## Planning Officer's Report – LDCA JULY 2020

<b>APPLICATION</b>	<b>2020/34</b> – Proposed three bedroom, split level dwelling.
<b>PERMISSION SOUGHT</b>	Permission in <b>Full</b>
<b>REGISTERED</b>	31 <sup>st</sup> March 2020
<b>APPLICANT</b>	Natasha Thomas
<b>PARCEL</b>	NG0471
<b>SIZE</b>	0.17 acres (698m <sup>2</sup> )
<b>LAND OWNER</b>	Crown Estates
<b>LOCALITY</b>	Clay Gut
<b>ZONE</b>	Intermediate
<b>CONSERVATION AREA</b>	None
<b>CURRENT USE</b>	Vacant – Crown Estates
<b>PUBLICITY</b>	The application was advertised as follows: <ul style="list-style-type: none"><li>▪ Sentinel Newspaper on 2<sup>nd</sup> April 2020</li><li>▪ A site notice displayed in accordance with Regulations.</li></ul>
<b>EXPIRY</b>	16 <sup>th</sup> April 2020
<b>REPRESENTATIONS</b>	None Received
<b>DECISION ROUTE</b>	<del>Delegated</del> / <b>LDCA</b> / <del>EXCO</del>

*Application 2020/34*

**Diagram 3: Site Plan**

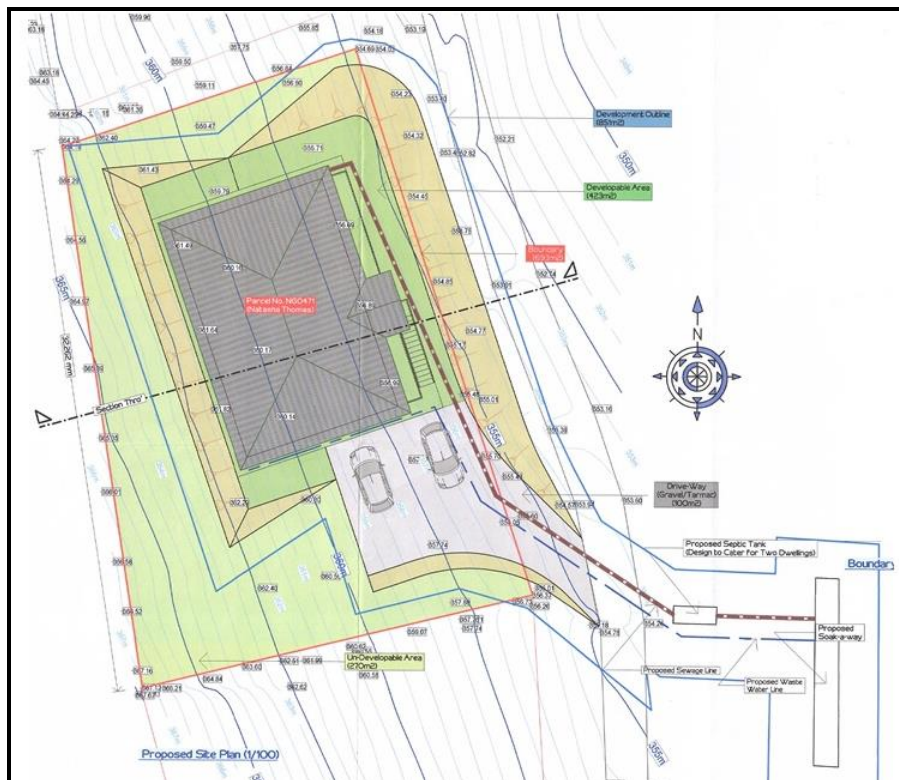
However, the excavated soil spill is proposed to be placed on Crown Land adjacent to the development site. Under the consultation response from Crown Estates it was conditioned that permission for soil placement on Crown land will be granted subject to planning approval. Crown Estates in their consultation response also gave permission subject to planning approval for the erection of a septic tank and soakaway system and access road on Crown Land.

While the septic tank and soakaway is proposed for this development, a percolation test is required to determine design and dimensions of either a traditional soakaway or drainage field.

**Diagram 4: Site Section**

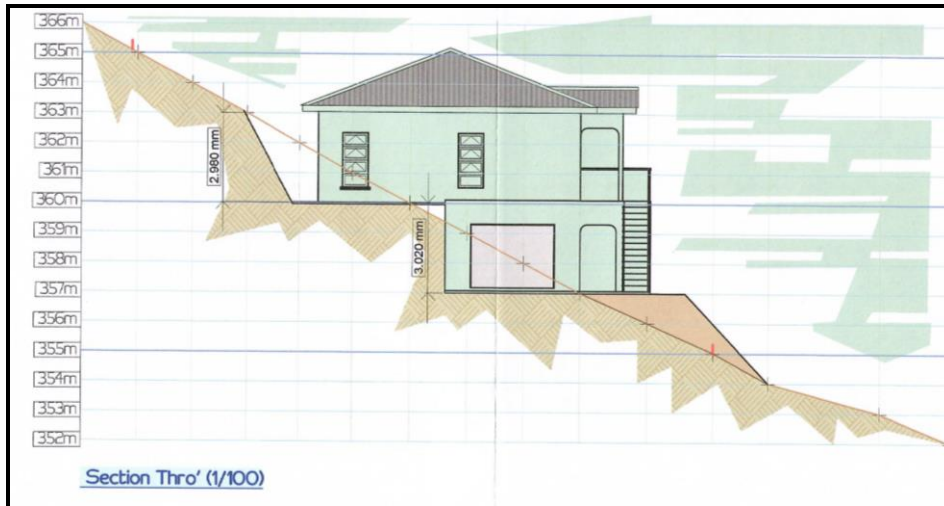
The proposed site excavation allows for a rear embankment height of less than 3m thus complying with LDCP 2012-2022 Intermediate Zone Policy IZ1 (f) “*the design and layout do not generally entail excavation nor making up of levels to a depth or height in excess of 3m.*”

While the dimensions and design of the excavated site complies with the LDCP policies surrounding the building, there is a section of the building that is proposed to be erected through the makeup soil spill which will require additional structural designs when submitted for building regulation approval. The embankments on the lower level on both sides of the building, as a result of the proposed site excavation, may require retaining due to its vertical cut. This may also require the placement of gabions but will be determined under the building control process.

**Diagram 5: Plan (ground floor)**

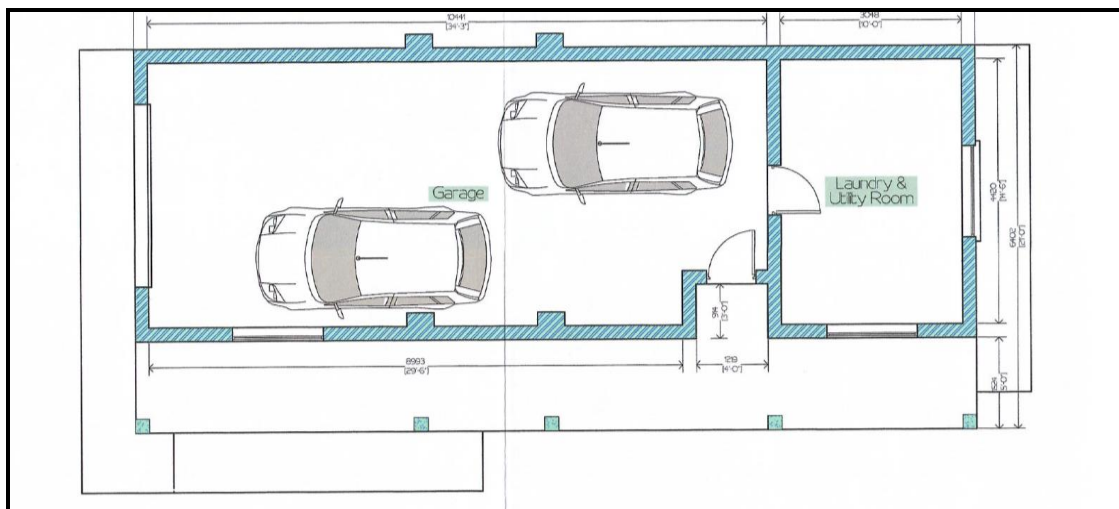
The split-level proposal is designed to best suit the sloped land allowing embankment heights to comply with LDCP policies, however, due to a section of the building being constructed outside of the excavated level platform a proposed engineered design foundation with supporting walls will need to be submitted with the building regulation application.
